PlanGrid Task Report - Feb 8, 2024

4 tasks in this report.

L04916_Princeton Woods FSU (Dumfries, VA)

#123 [CNTL 098] Ansul pull labeling.

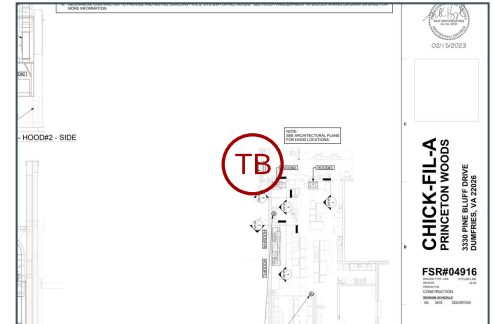
Label all Ansul pull stations for which hoods they serve.

#122 [CNTL 107] (MISC) Missing Ansul pull stations

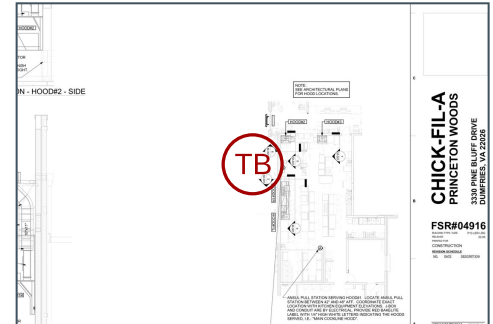
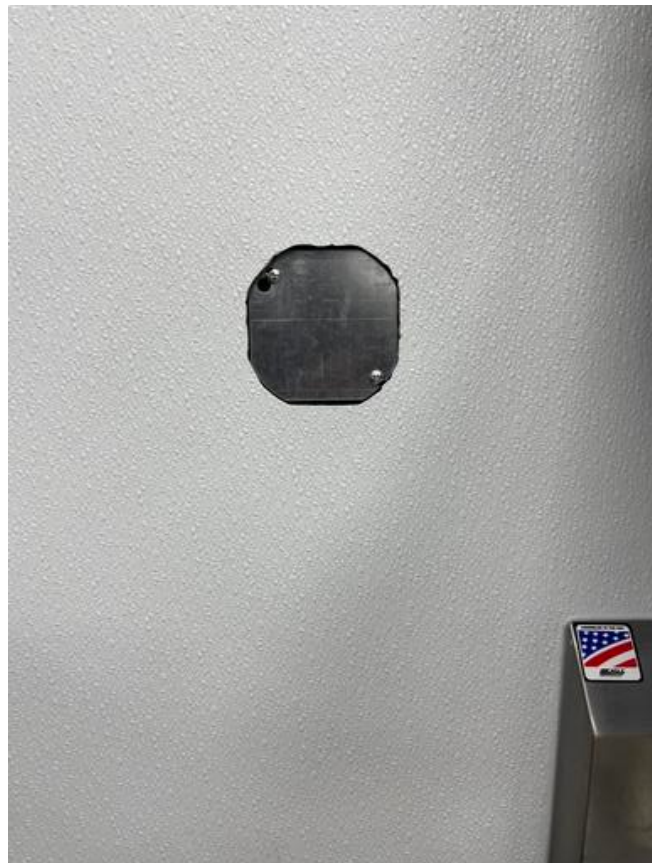
Ansul pull stations are not yet installed at locations designated

#120 [EXHA 127] Grease exhaust duct is not supported.

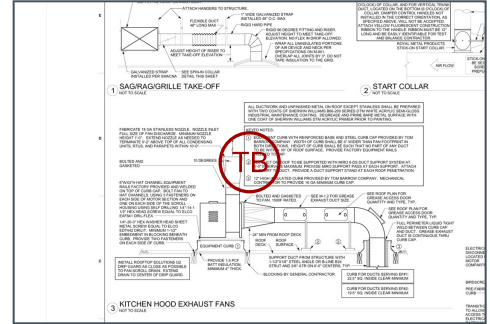
Exhaust duct for EF#1 is to be supported per kitchen hood exhaust fan detail on 6'0" centers.
